BEFORE THE MERIDIAN CITY COUNCIL

CASE NO. FP-2024-0025

ORDER OF CONDITIONAL
APPROVAL OF FINAL PLAT

SUBJECT: Tanner Creek No. 1
FP-2024-0025

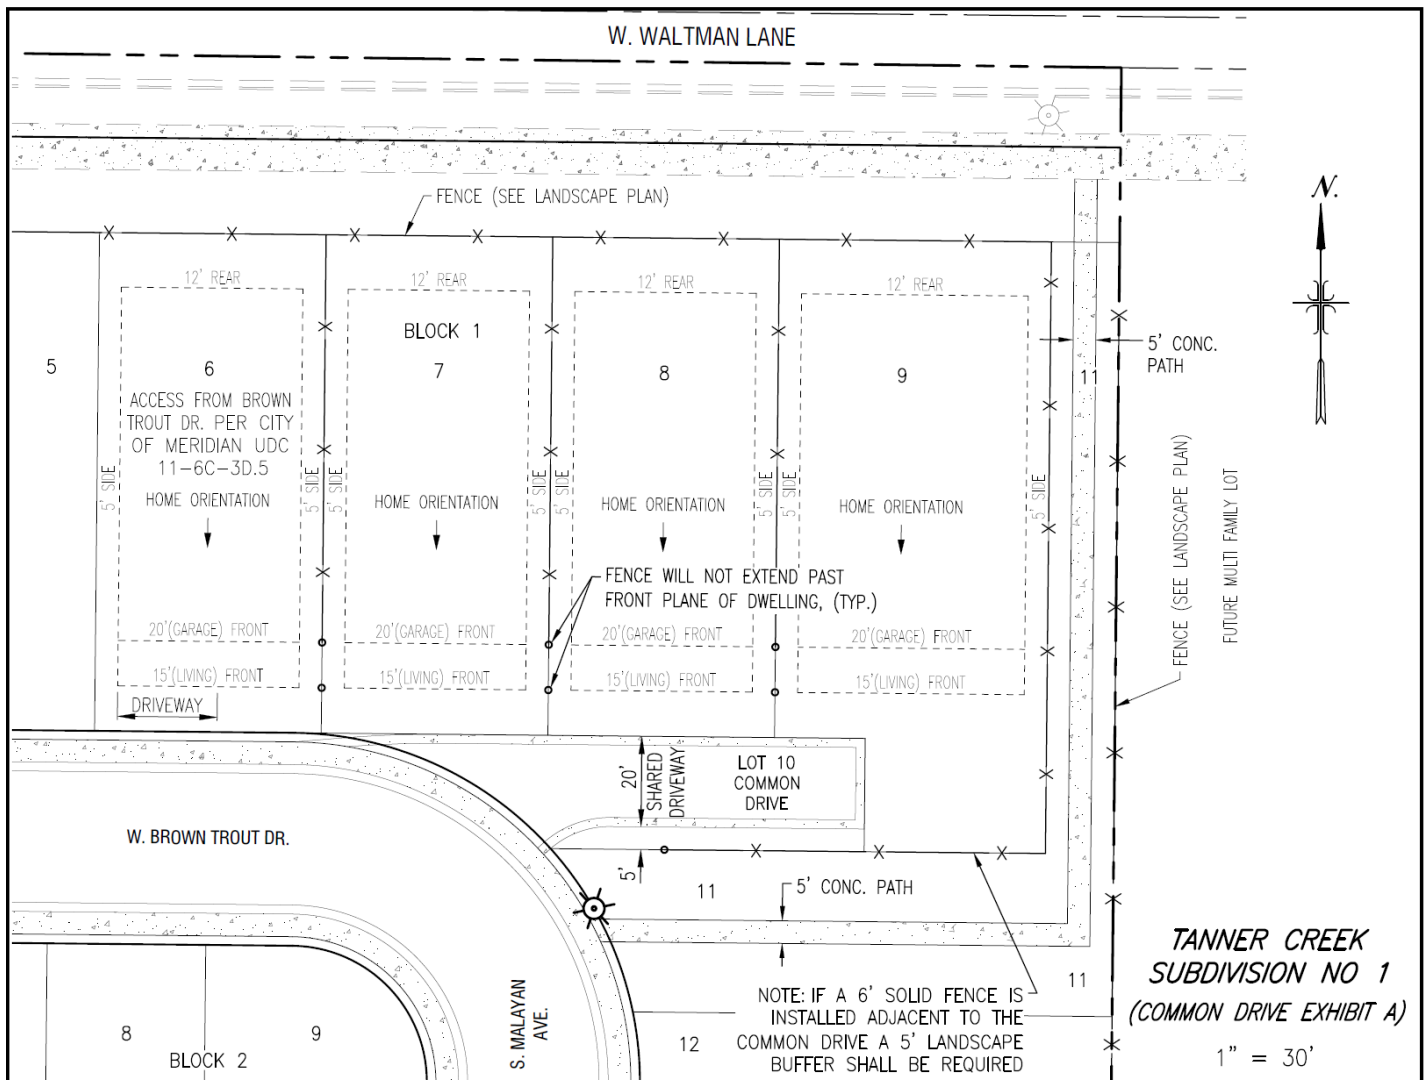
3. Prior to submittal for the City Engineer's signature, have the Certificate of Owners and the accompanying acknowledgement signed and notarized.
4. The final plat shown in Section V.B prepared by Land Solutions Land Surveying and Consulting, stamped on 11/8/2024 by Clinton W. Hansen, shall be revised as follows:

- a. Lot 6, Block 5 needs to be revised to meeting the minimum lot size of 4,000 square feet.
 - b. Depict an ingress-egress easement across Lot 1, Block 5 to the outparcel at the northwest corner of the site (i.e. Martinez property #S1213428080) in alignment with W. Brown Trout Dr. for future access.

- c. Include the recorded easement number for the City of Meridian sewer and water easement graphically depicted on Sheet 1.
 - d. Include the recorded instrument number for the access easement graphically depicted on Sheet 1.

- e. Include the recorded instrument number for the ACHD easement line noted in the Legend.
 - f. Note #10: Include the recorded instrument number of the development agreement (i.e. #2024-007677).

- g. Note #12: Include the recorded instrument number of the ACHD temporary license agreement.
 - h. Note #15: The note shall include a requirement for maintenance of a paved surface capable of supporting fire vehicles and equipment per UDC 11-6C-3D.8. Change "blanket cross access" to "perpetual ingress egress" easement.

An electronic copy of the revised plat shall be submitted prior to signature on the final plat by the City Engineer.

Job Number: 2421
Drawn: Checked
Scale: AS SHOWN
Sheet Title: LANDSCAPE PLAN
Sheet Number: L1
1 of 4 Sheets

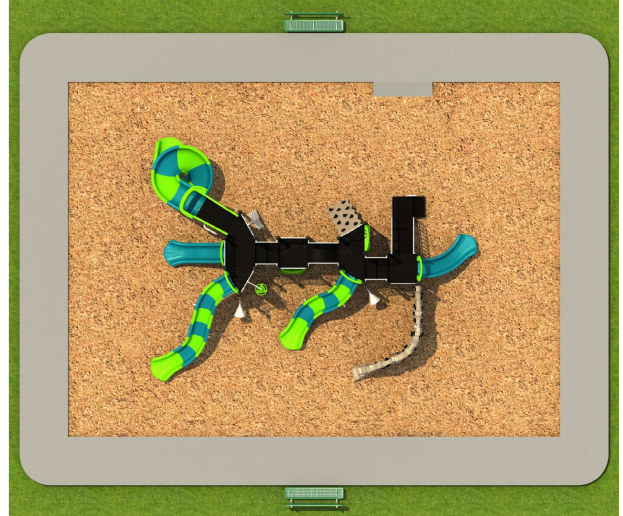
5. The landscape plan shown in Section V.C, dated 12/18/24, shall be revised as follows:
 - a. Depict a driveway across Lot 1, Block 5 to the outparcel at the northwest corner of the site (i.e. Martinez property #S1213428080) in alignment with W. Brown Trout Dr. for future access.
 - b. The open space landscape requirements on the Landscape Calculations table shall be revised to reflect the updated standard of one (1) deciduous tree for every 5,000 square feet of common open space as set forth in UDC 11-3G-5B.3.
 - c. Include mitigation information as applicable for tree preservation in accord with the standards listed in UDC 11-3B-10C.
 - d. Widen the sidewalk/multi-use pathway in the street buffer along Waltman Ln. to 10-feet in accord with UDC 11-3G-3B.3 per preliminary plat condition #3h.

- e. In the street buffer along Waltman Ln., depict enhanced landscaping as set forth in UDC 11-3B-7C.3f for entryway corridors and comply with the standards listed in UDC 11-3G-3B.3 in accord with preliminary plat condition #3h. Include a note stating how you're complying with these standards.
